MASSACHUSETTS INSTITUTE OF TECHNOLOGY
INVESTMENT MANAGEMENT COMPANY
One Broadway, 9th Floor, Suite 200
Cambridge, MA 02142

Re: Modifications to Volpe Site Plan / Special Permit Application (PB #368)

Figure 1: Site Plan

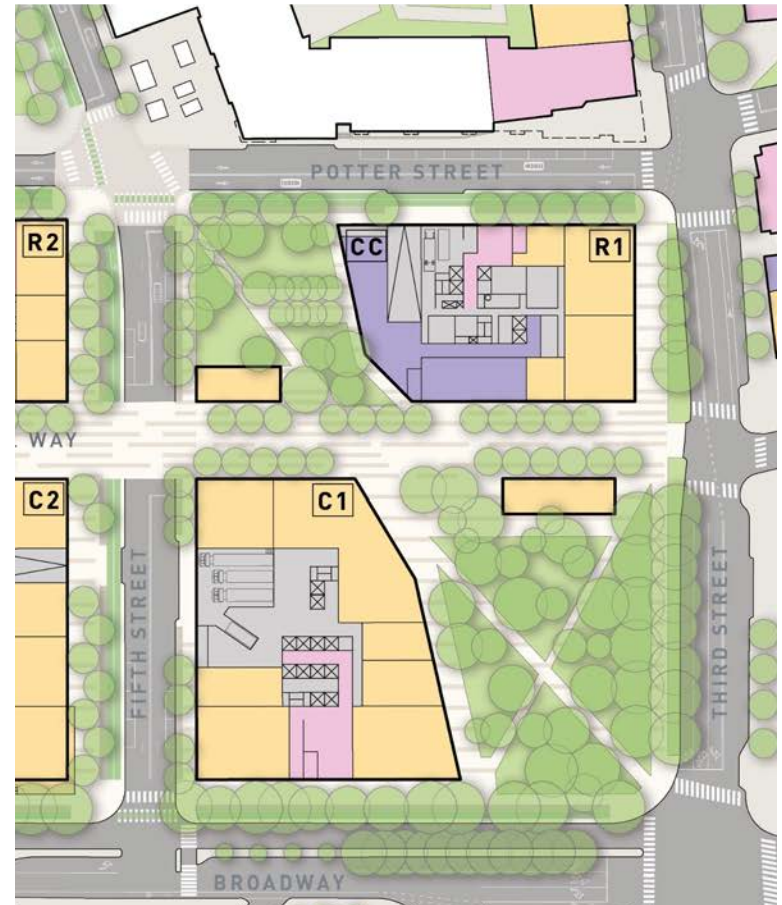
Over the past few months, our abutters at 303 Third Street have raised concerns about the impacts of proposed structures along Potter Street in front of their property. In addition, we were asked to consider adding open space to our proposal. The current site plan includes a stand-alone community center and a residential building (R1) with upper floor plates of approximately 14,600 square feet in front of 303 Third Street. We are proposing a new option that connects the community center to the “RI” residential building.

This proposed change creates more usable open space and gives the community center access to a bigger open space adjacent to its most prominent entry. This not only creates a third significant open space at the Volpe site, it gives us more flexibility in designing and programming the community center outside of a more limited footprint.

In addition, this option significantly reduces the upper floor floorplates of Building R1 to approximately 11,000 square feet and relocates residential square footage to residential buildings “R2” and “R3” situated farther west on Potter Street. We presented this option to our neighbors and the broader community at an open space workshop on March 25th. This option was well received in general and we look forward to obtaining your input when we come to the Planning Board on April 6th.
